ATLANTIC MARINE CENTER
EVALUATION REPORT

REGISTRY NO.: FE-243WD

Louisiana, Gulf of Mexico, Approach to Calcasieu Pass

WIRE DRAG FIELD EXAMINATION-243WD
 LOUISIANA, GULF OF MEXICO
 APPROACH TO CALCASIEU PASS

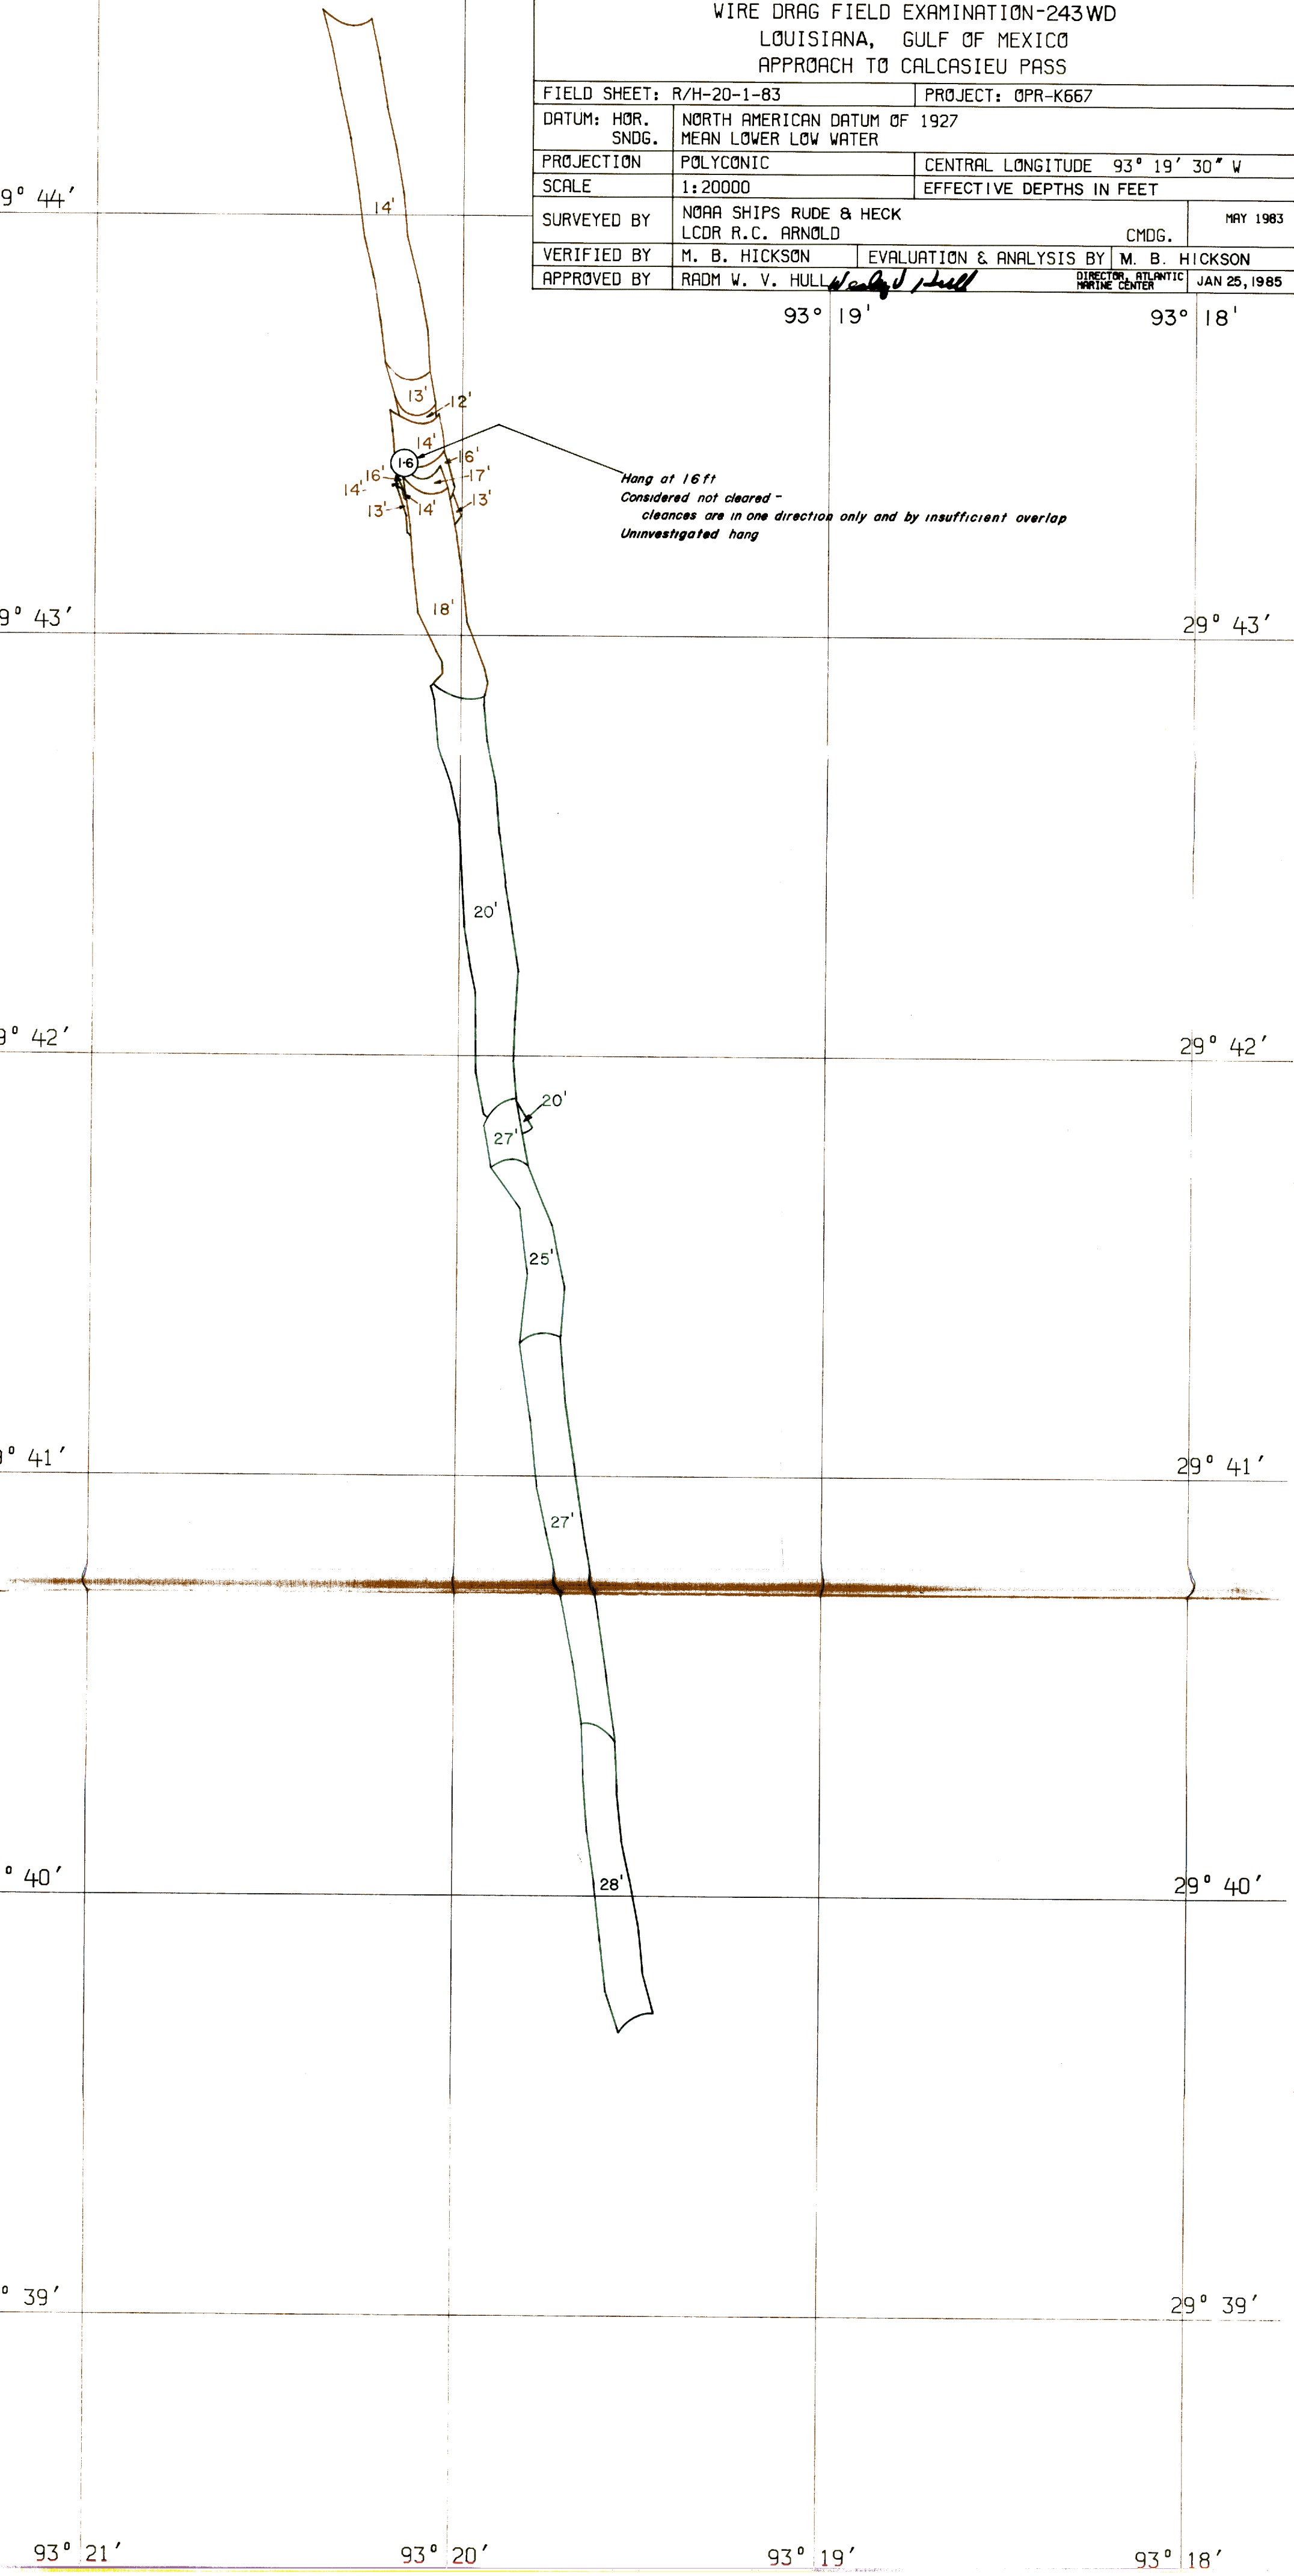
Hang at 16ft
 Considered not cleared -
 clearances are in one direction only and by insufficient overlap
 Uninvestigated hang
